# CORNWALL CONDOMINIUMS

## 2ND FLOOR CONDOMINIUM RENOVATIONS JOB NO. 201812.04

# PERMIT SET

**APPROVED**  
**Subject to Field**  
**Inspection**  
12/09/2020 4:08:46 PM  
Kelsey Brender

1 PROPOSED FIRST FLOOR PLAN  
1/4" = 1'-0"

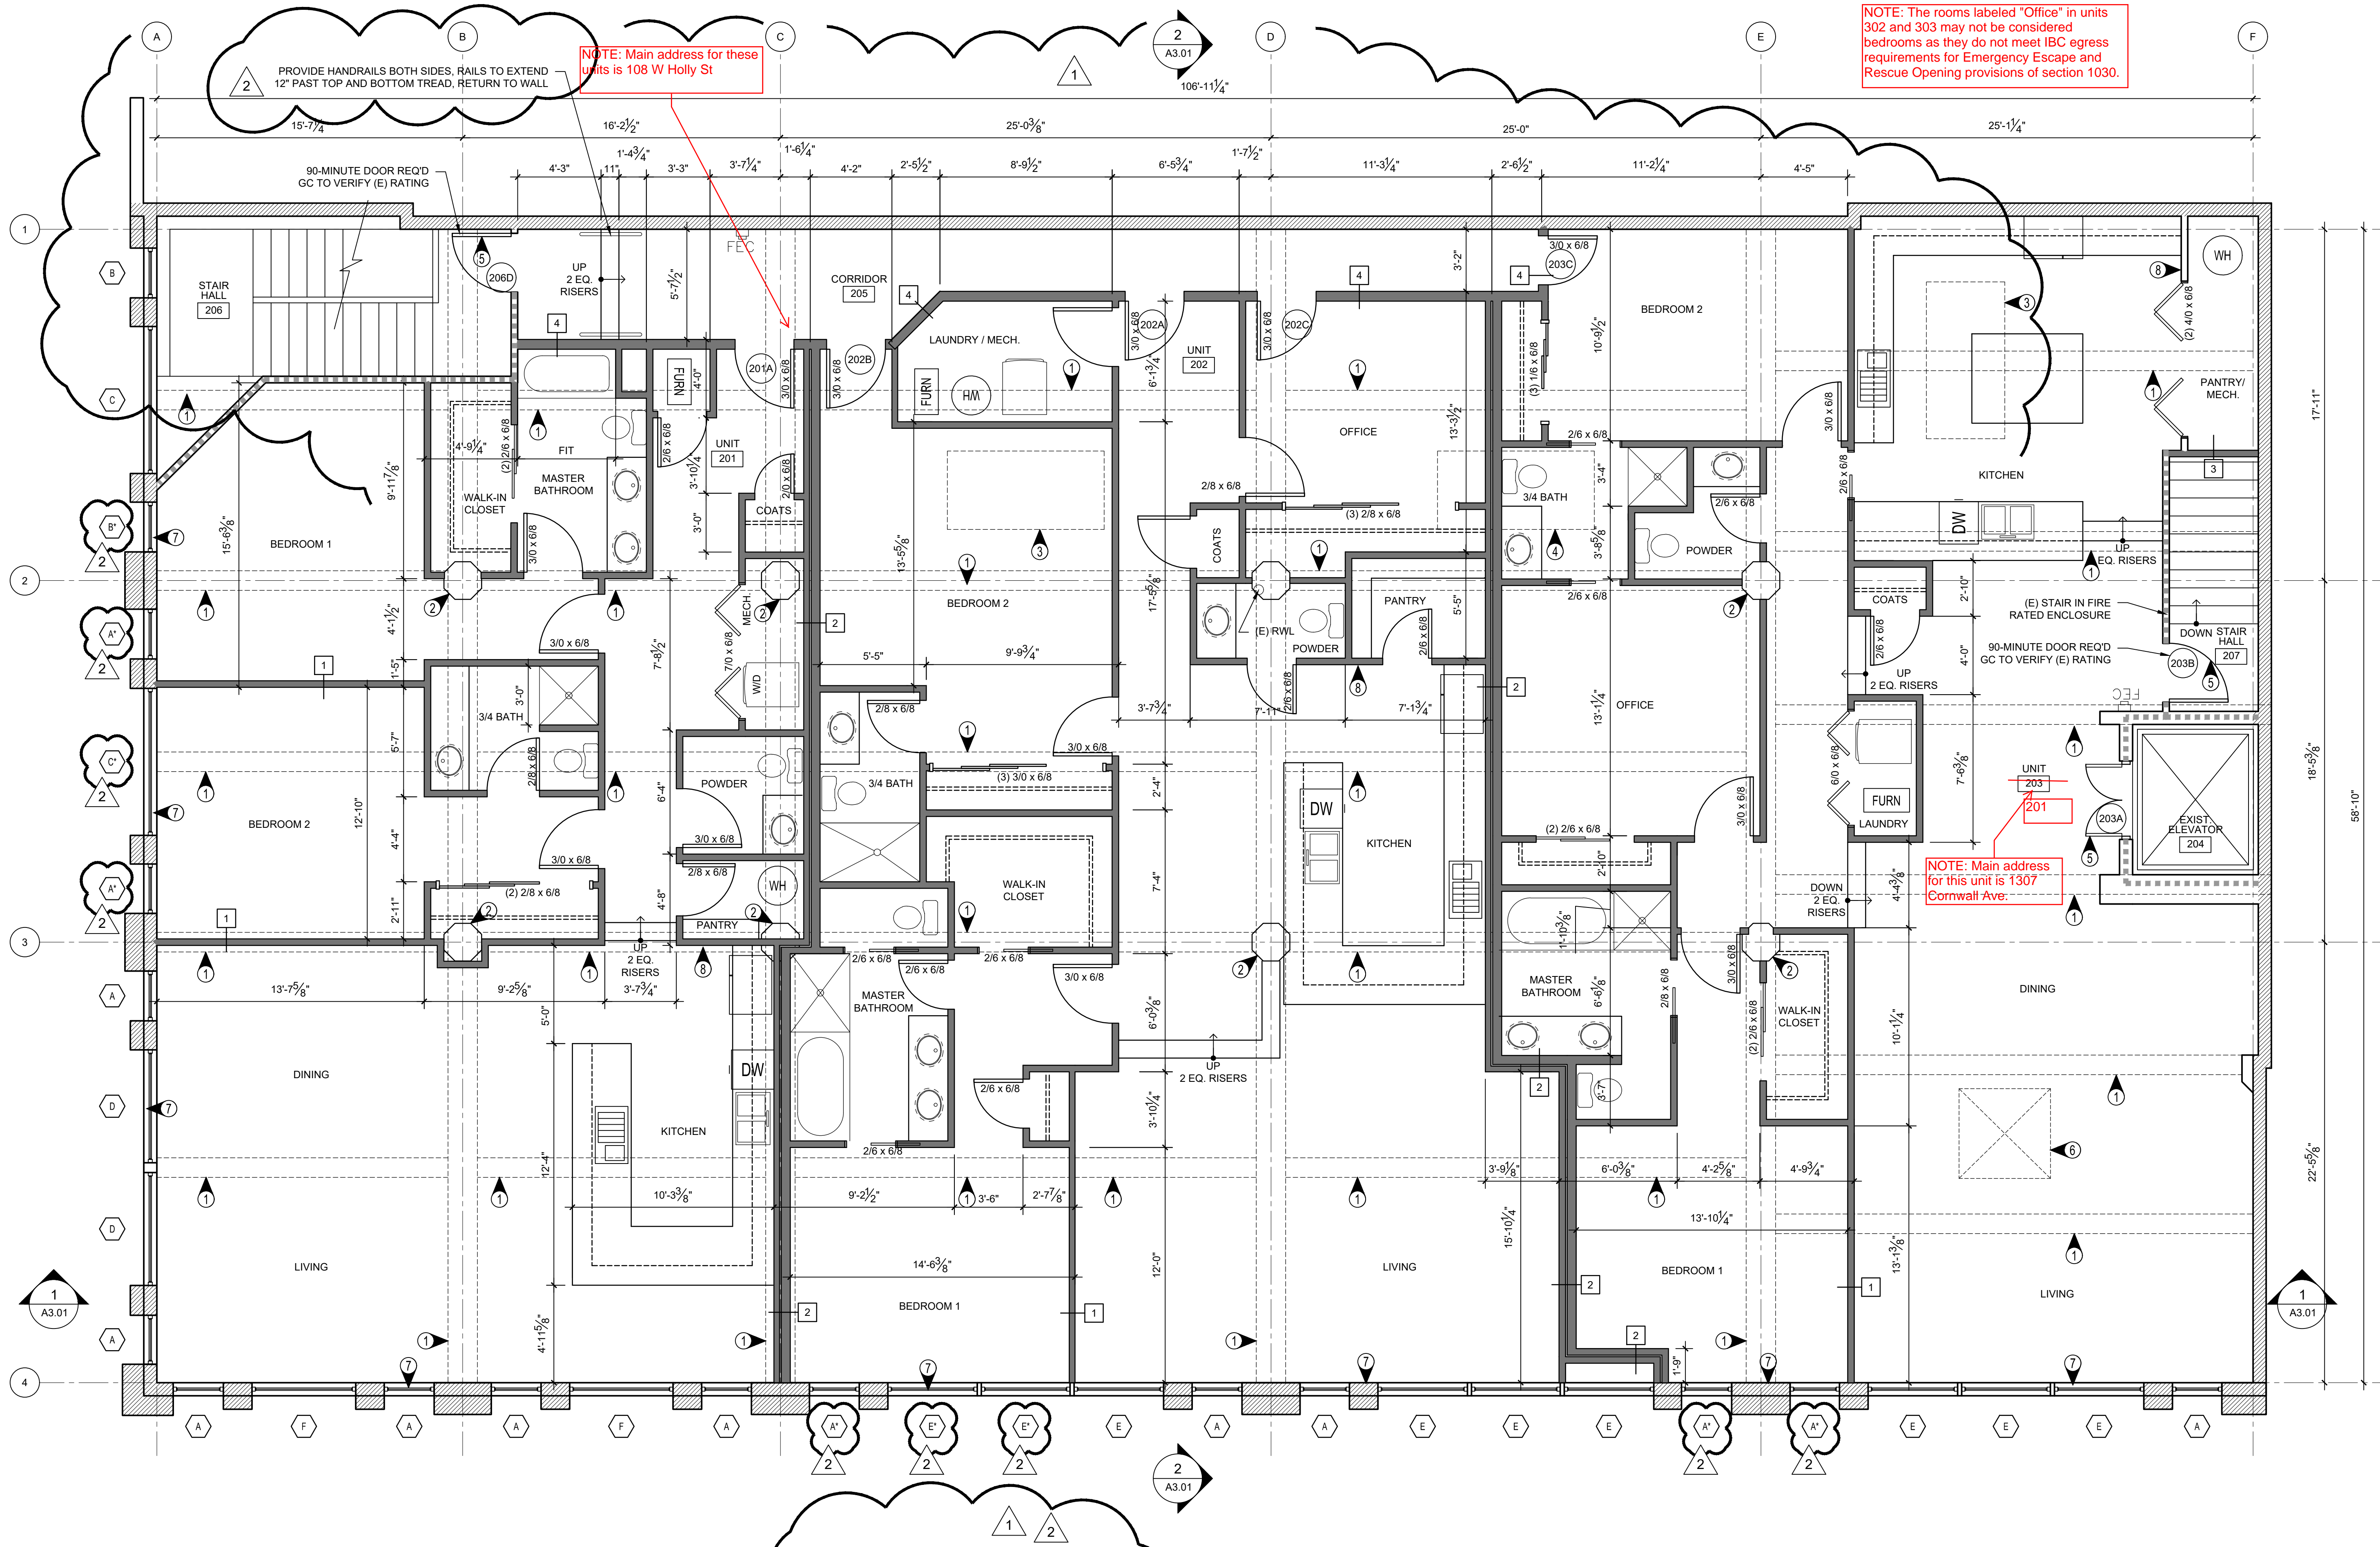
STORAGE IS NOT PERMISSIBLE BENEATH EXIT STAIR. CONFIRM SPACE IS NOT USED FOR STORAGE

NOTE: Add street address above or adjacent to door and unit numbers that can be accessed from this door. Main address shall be 6" tall, unit numbers may be 3" tall. They should be white if on glazing. Numbers are prohibited from being on an operable door.

NOTE: First floor does not have suite numbers. Each tenant space has been assigned an individual street address.

NOTE: Display address number and unit number that can be accessed from this location. #201

NOTE: DCDA Required on fireline.

1 PROPOSED SECOND FLOOR PLAN  
1/4" = 1'-0"

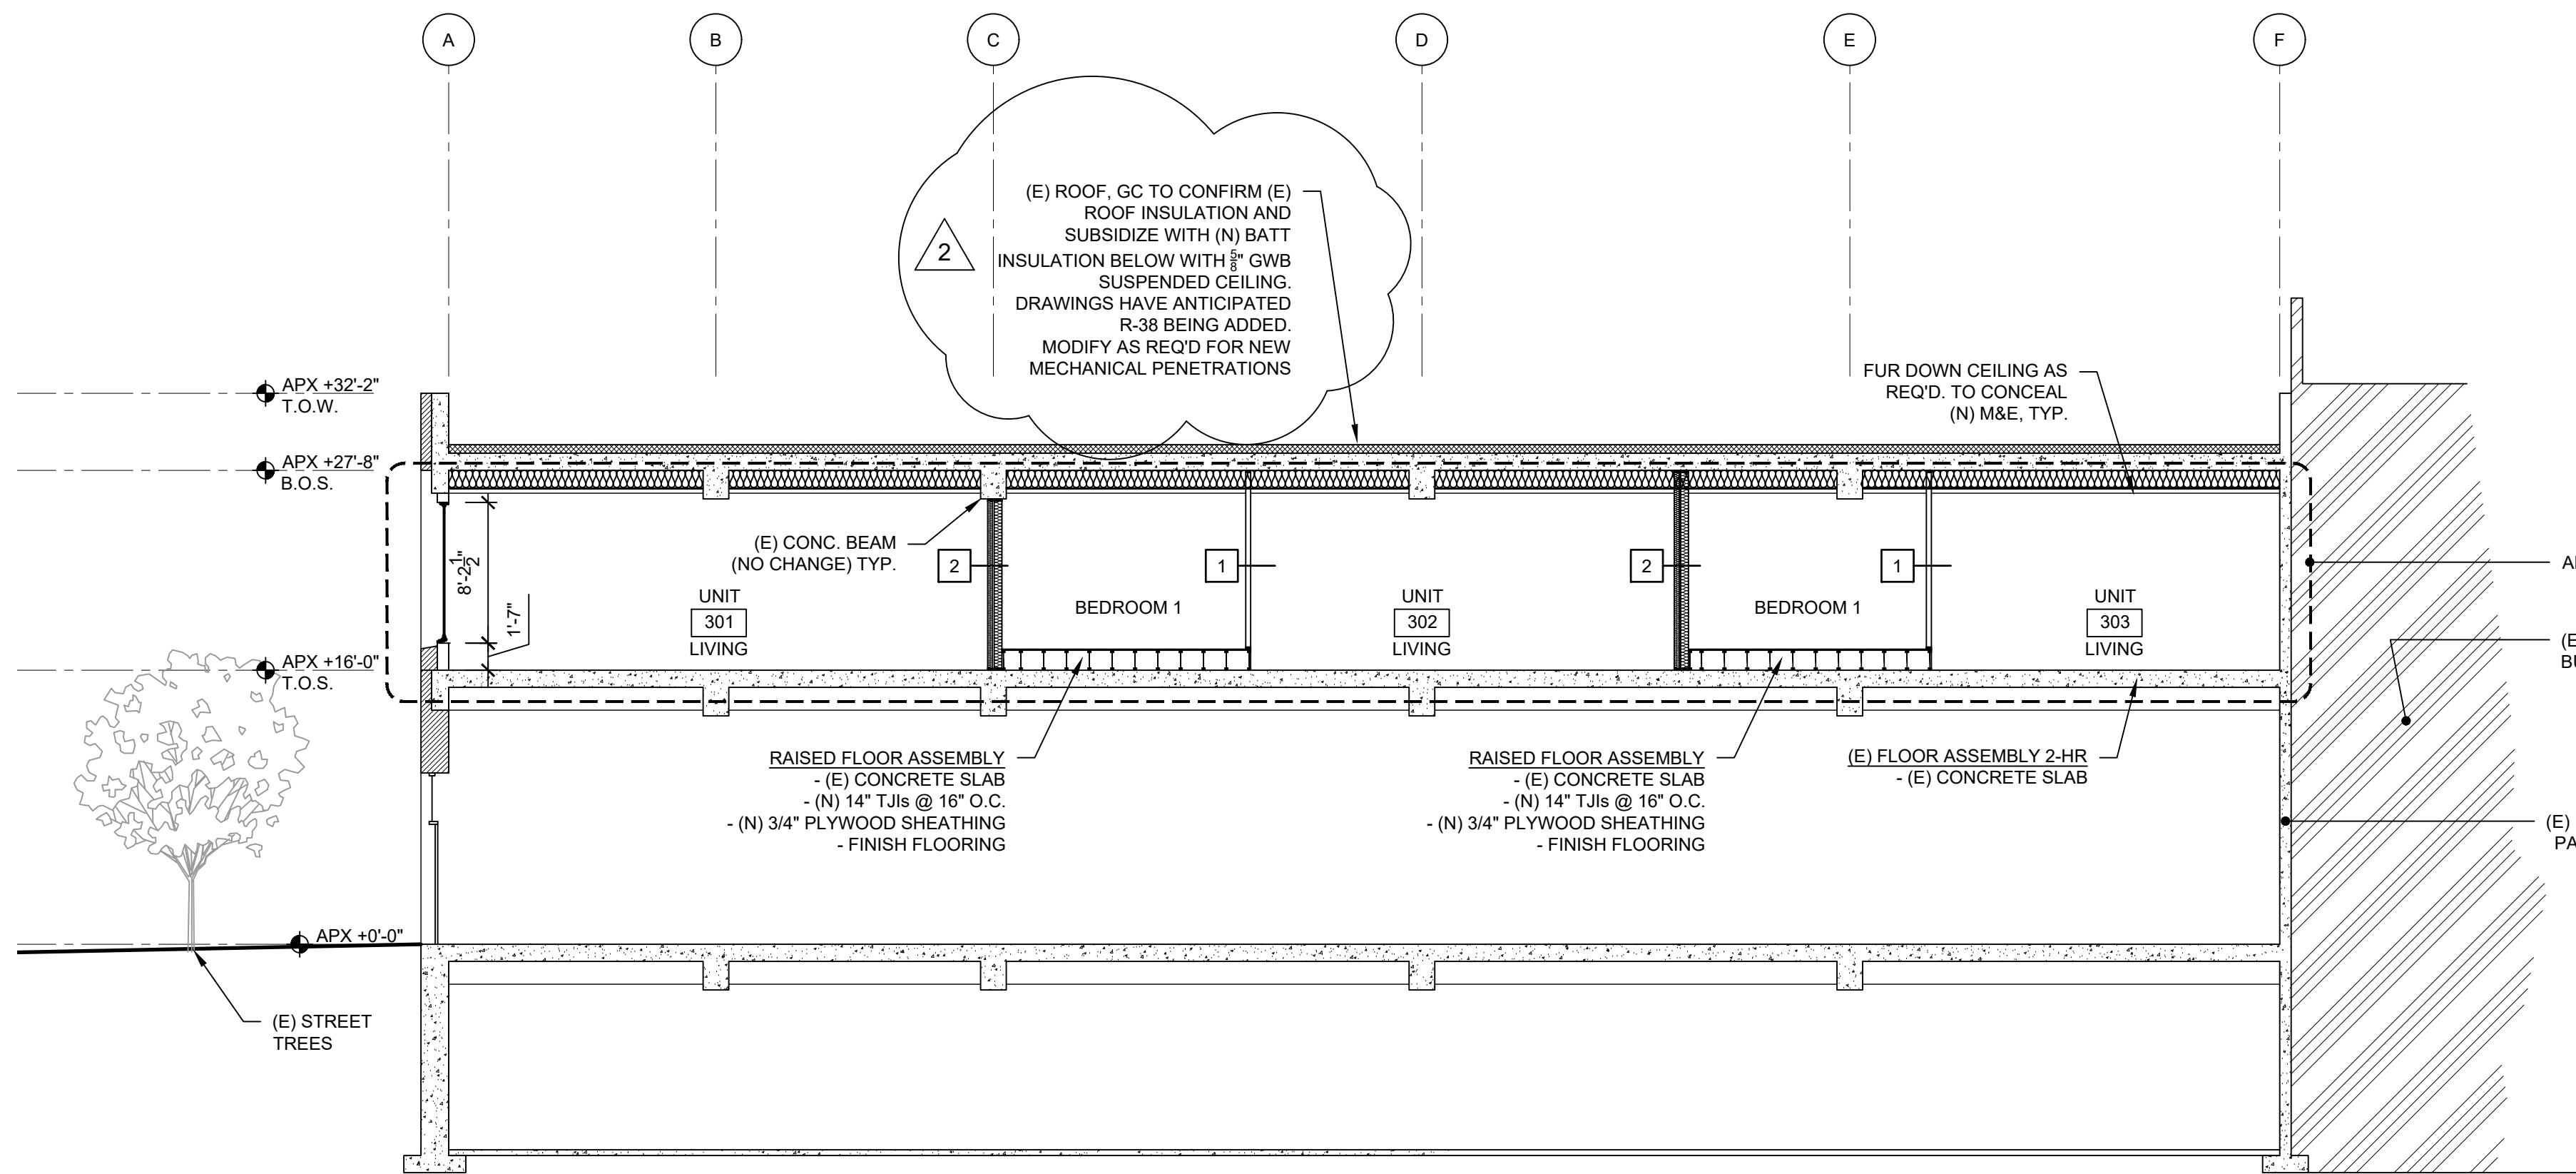
NOTE: The rooms labeled "Office" in units 302 and 303 may not be considered bedrooms as they do not meet IBC egress requirements for Emergency Escape and Rescue Opening provisions of section 1030.

NOTE: Main address for these units is 108 W Holly St

NOTE: Main address for this unit is 1307 Cornwall Ave.
